**ITEM #3 - PRELIMINARY PLAT
PEACEFUL ACRES JACKSON'S GARDEN NO. 2**

KPB File No.	2025-064
Plat Committee Meeting:	May 27, 2025
Applicant / Owner:	Harold Arthur Jackson III and Bobbie Jean Jackson of Soldotna, Alaska
Surveyor:	Jerry Johnson; Johnson Surveying
General Location:	Johns Road, Liisia Dawn Street and Marty Lane, Kalifornsky Area

STAFF REPORT

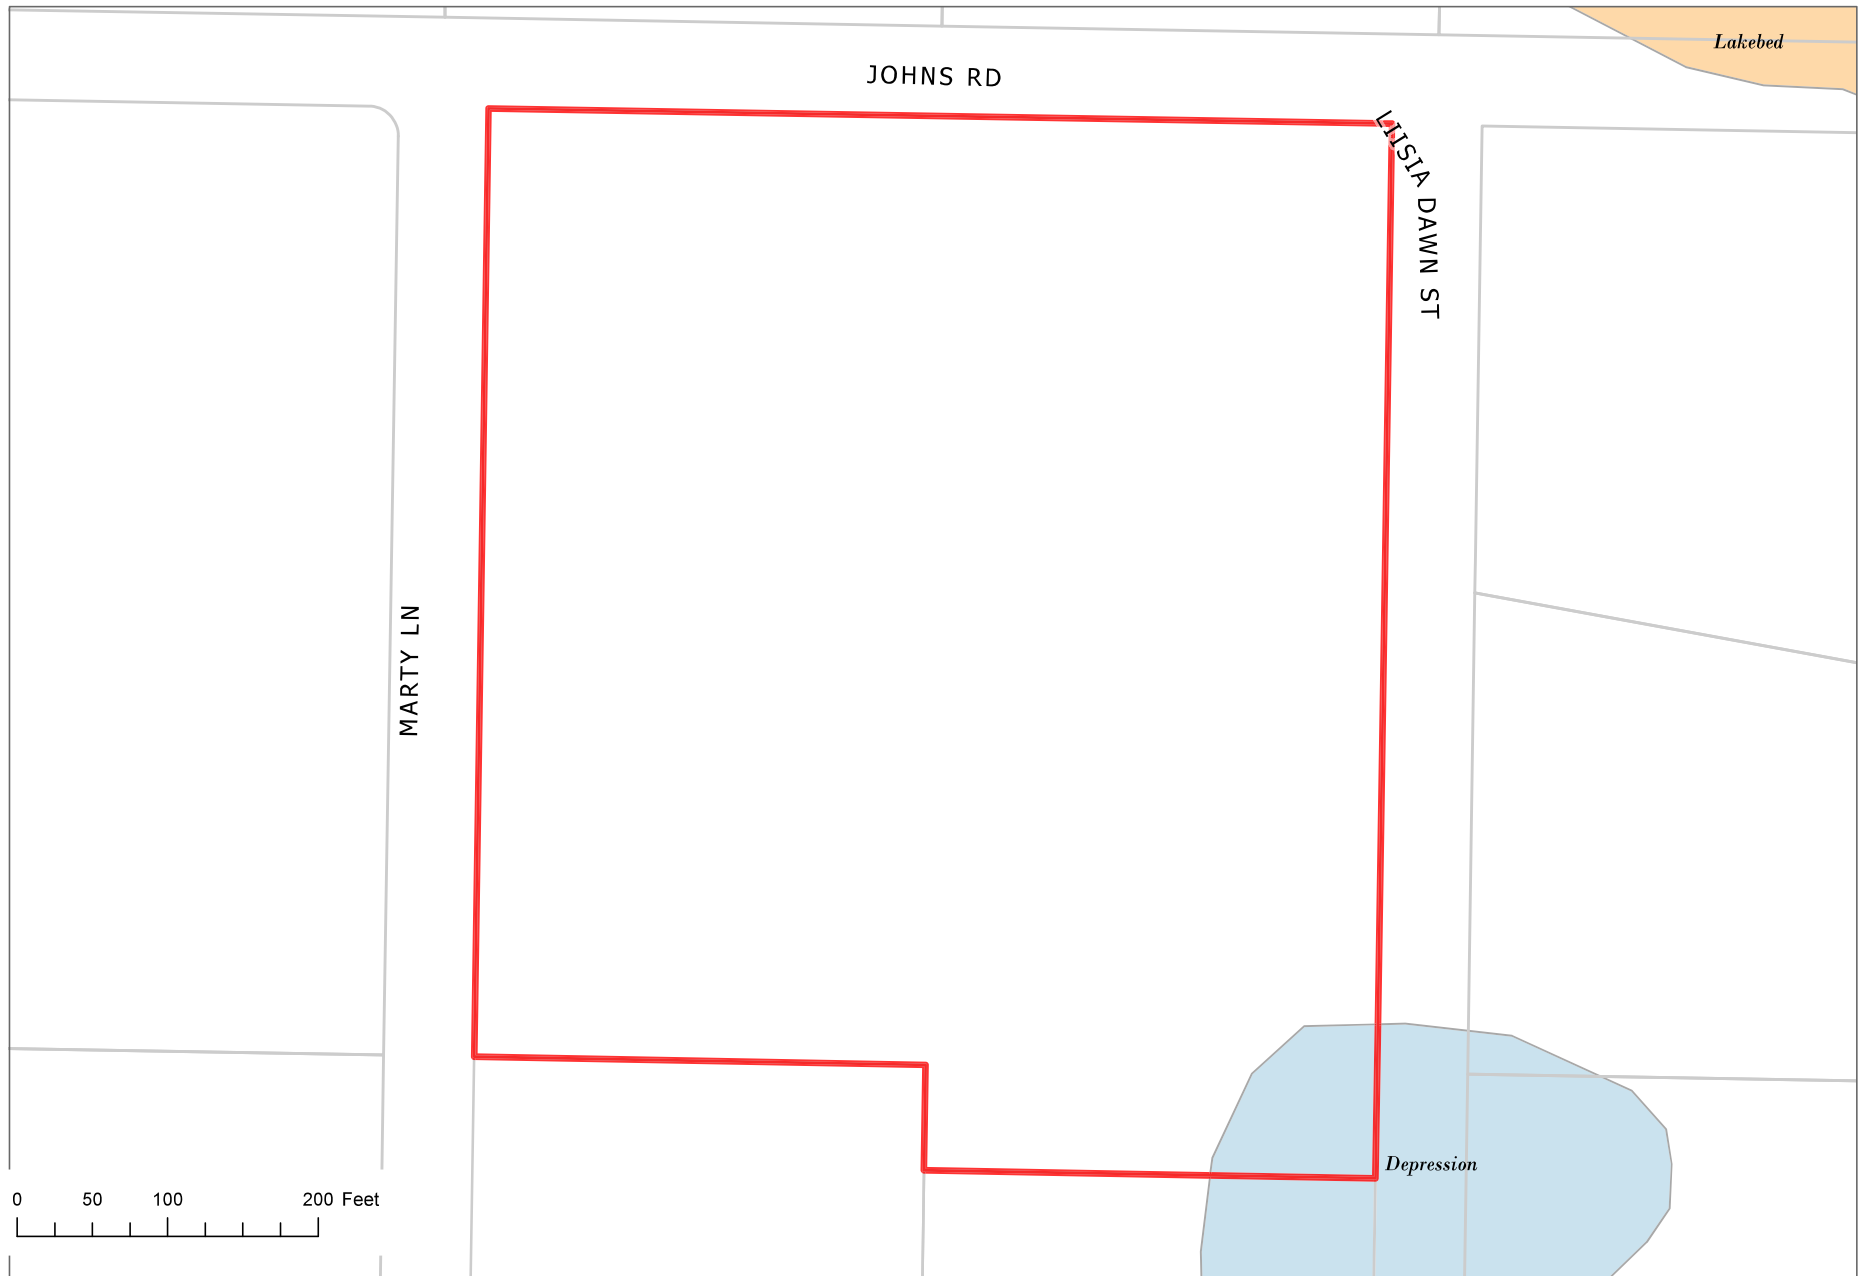
There appears to be a drive from coming from Liisia Dawn St through proposed Tract D1B to proposed Tract D1A. If this drive will remain with the intent as an access; **Staff recommends** the surveyor depict this drive and label it as private.

on the preliminary plat. Two greenhouses are located on the west boundary of proposed Tract D1A, encroaching approximately 1 foot into the building setback and a carport into the right-of-way of Marty Lane. According to KPB GIS Imagery, there is a greenhouse located on the north boundary line of proposed Tract D1 not shown. There are also cabins on proposed Lot D1B shown. **Staff recommends** the surveyor to confirm the location of the structures and depict them on the plat with dimensions and distances to line, if encroaching into the building setback.

Staff recommends a Building Setback Encroachment Permit must be applied for the any of the buildings encroaching into the building setback, including the carport. Additionally, a permit must be applied for through the KPB Roads department for the carport encroaching into the right-of-way. Alternatively, the owners may choose to remove the carport. These permits must be completed and added as a note on the plat giving the date of approval and the filed Resolution information on the final plat. The plat shall also show the structures with reference to the plat note.

Contours have been added to the preliminary plat at intervals of 5-feet and correlate to KPB GIS Terrain Viewer. A small area in the southeast of the subject property has been shaded on the plat of slopes exceeding 20% grade. **Staff recommends** the surveyor may remove the contours on the final plat per KPB 20.60.010.

KWF Wetlands Assessment identified wetlands on the southeast corner of proposed Lot D1B. The wetlands have been added to the preliminary plat labeled as swamp limits. **Staff recommends** place a note on the final plat indicating "any person developing the property is responsible for obtaining all required local, state, and federal permits, including a U.S. Army Corps of Engineers wetland determination if applicable."

A 5-foot clearing and/or utility easement was granted by parent plat, Peaceful Acres Subdivision KN 74-48 along the north boundary of former Tract D. **Staff recommends** the surveyor carry this easement forward from KN74-18 as a note and label on the drawing.

- Modify the KPB File Number to 2025-064

- Remove "Block 1" from the legal description. KN 2006-112 did not include "Block" on the parcel labels and neither does KPB Assessing or any of the deeds.

- Modify the ROW name to the east: Liisia Dawn Street
- Modify the width of John's Road to 66 feet

- Staff suggests labeling Reflection Lake

- Remove the block numbers from the parcel labels to the east
- Modify the southeast parcel to KRD 2020-42 Tract B-1A
- Remove the block numbers from the parcel labels directly to the south

Peaceful Acres Jackson's Garden Replat

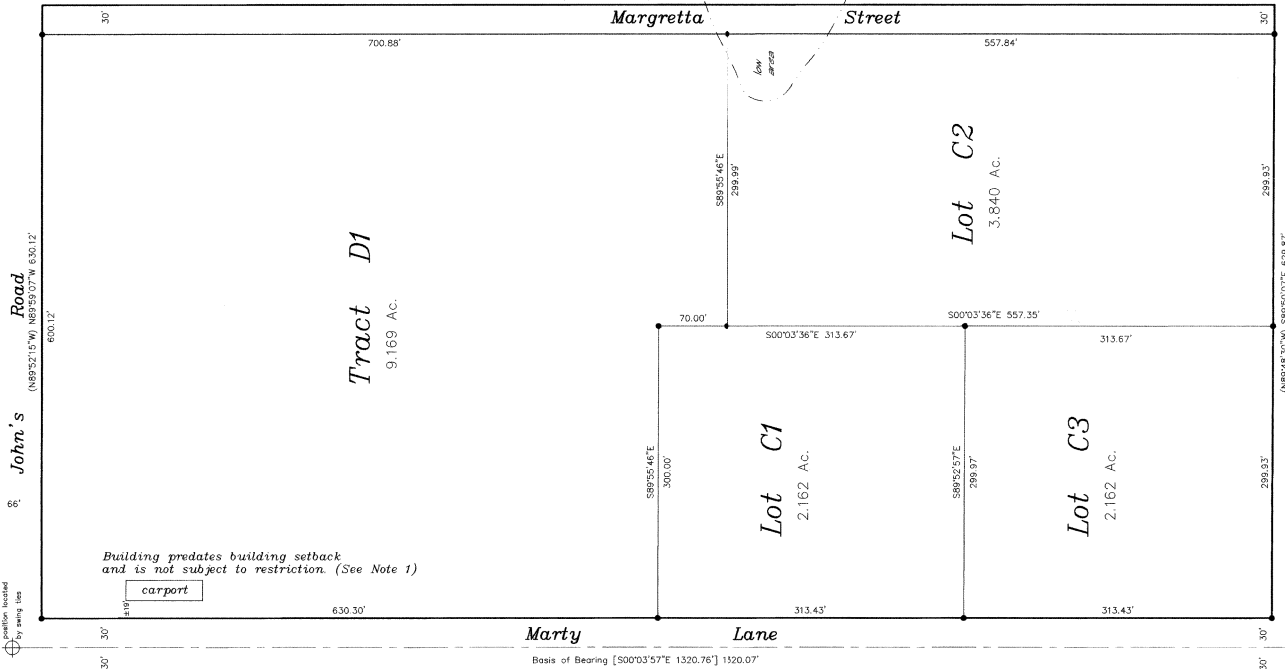
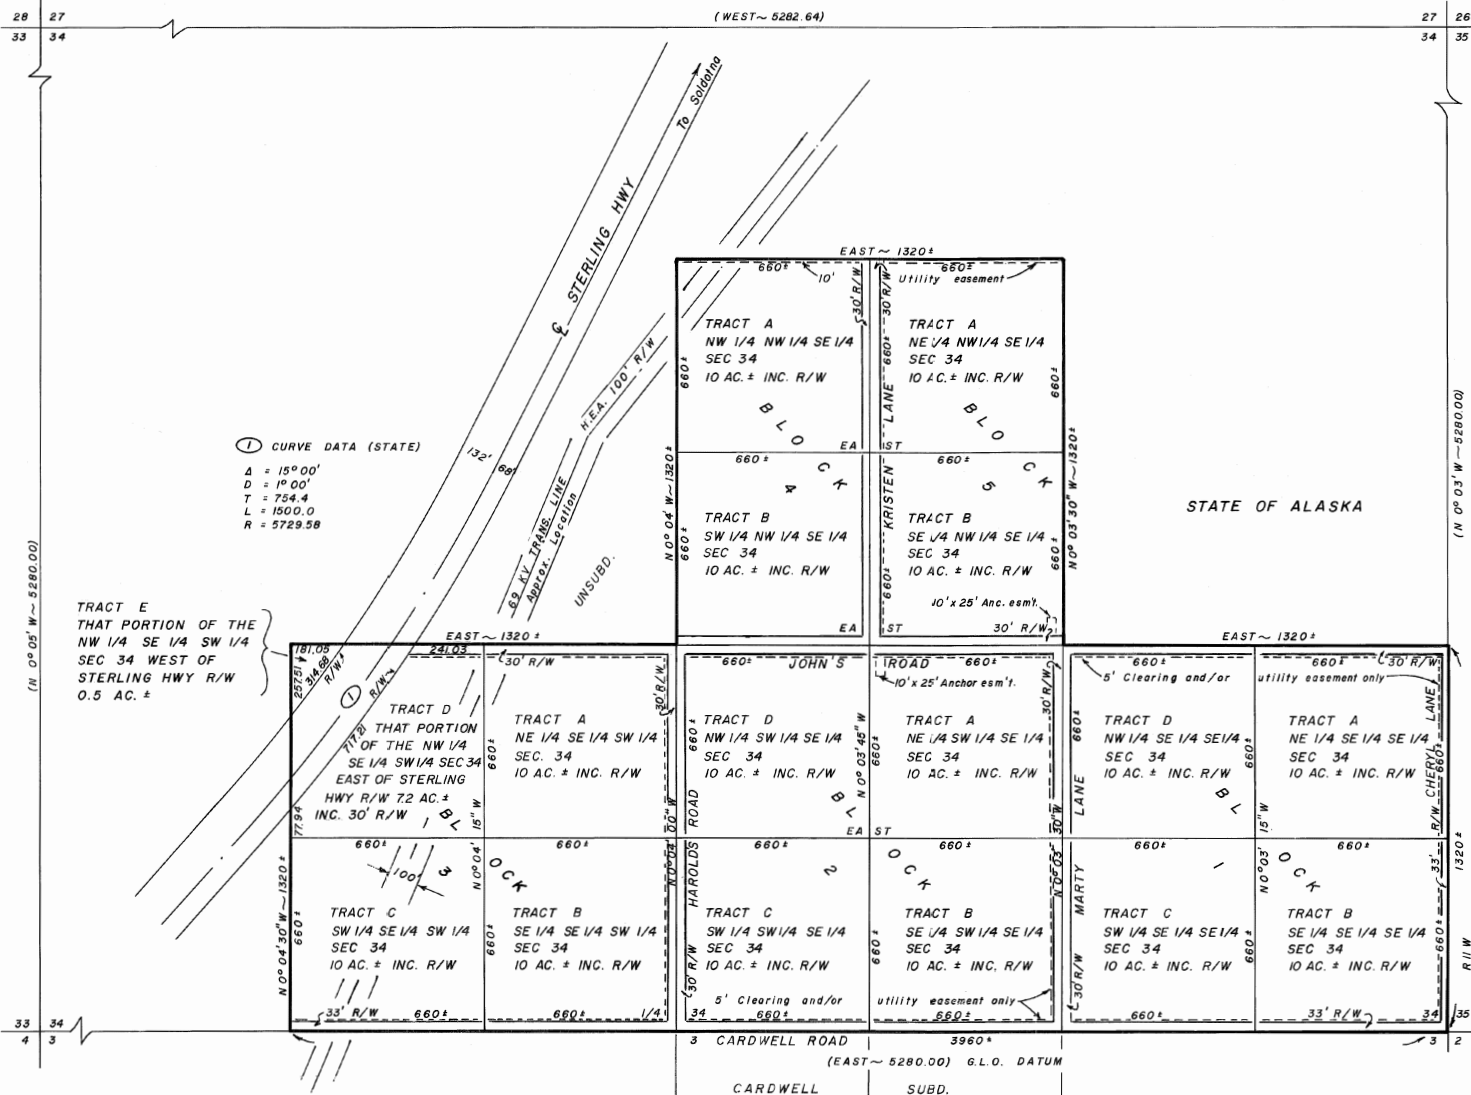
The parent plat, KN 2006-112, included a depiction of a pre-existing carport 19 feet from the west property line of former Tract D1 and was not subject to the building setback requirements. This is not the same carport shown on the current plat submittal. The greenhouse in the same location of the past carport looks to have replaced the old carport.
